DRAINAGE AND TRANSPORTATION INFORMATION SHEET

GRADING & DRAINAGE PLAN 8004 Camino Alto Ct. NW LOT 18, BLOCK 6, UNIT 22 VCS

RE: Lot 18 Block 6 Unit 22 Volcano Cliffs 8004 Camino Alto Ct NW Grading and Drainage Plan Engineers Stamp Date 5/21/15 (D10D003B18)

GRADING AND DRAINAGE PLAN
LOT 18, BLOCK 6, UNIT 22, VCS
ADDRESS: 8004 Camino Alto Ct NW

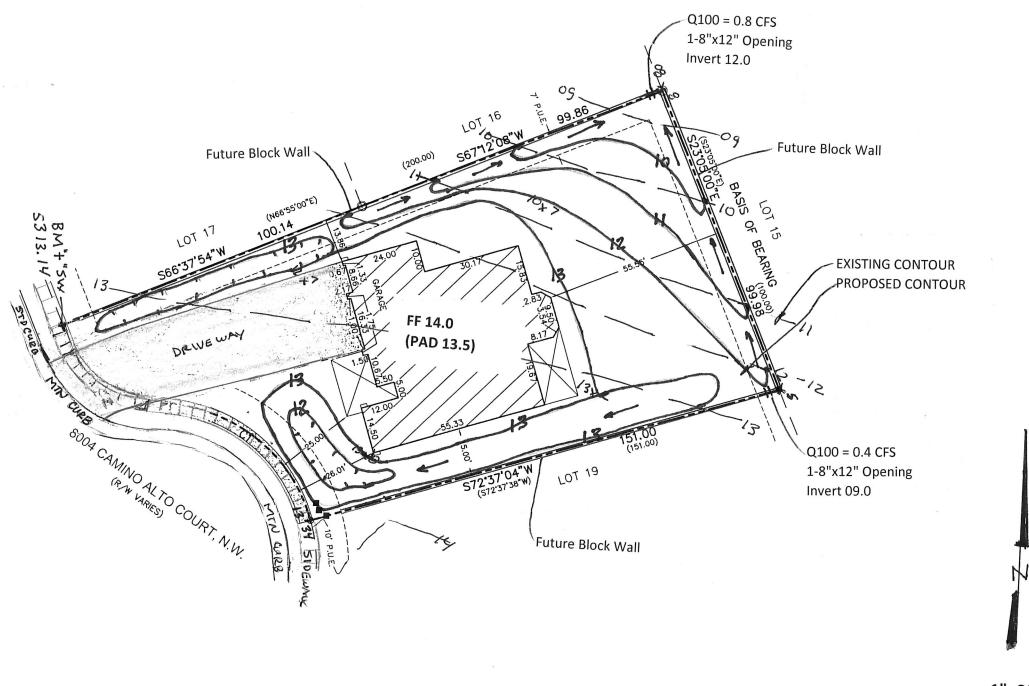
Based upon the information provided in your submittal received 5/21/2015, this plan is approved for Grading Permit and Building Permit.

Please attach a copy of this approved plan to the construction sets in the permitting process prior to sign-off by Hydrology.

Prior to Certificate of Occupancy release, Engineer Certification per the DPM checklist will be required.
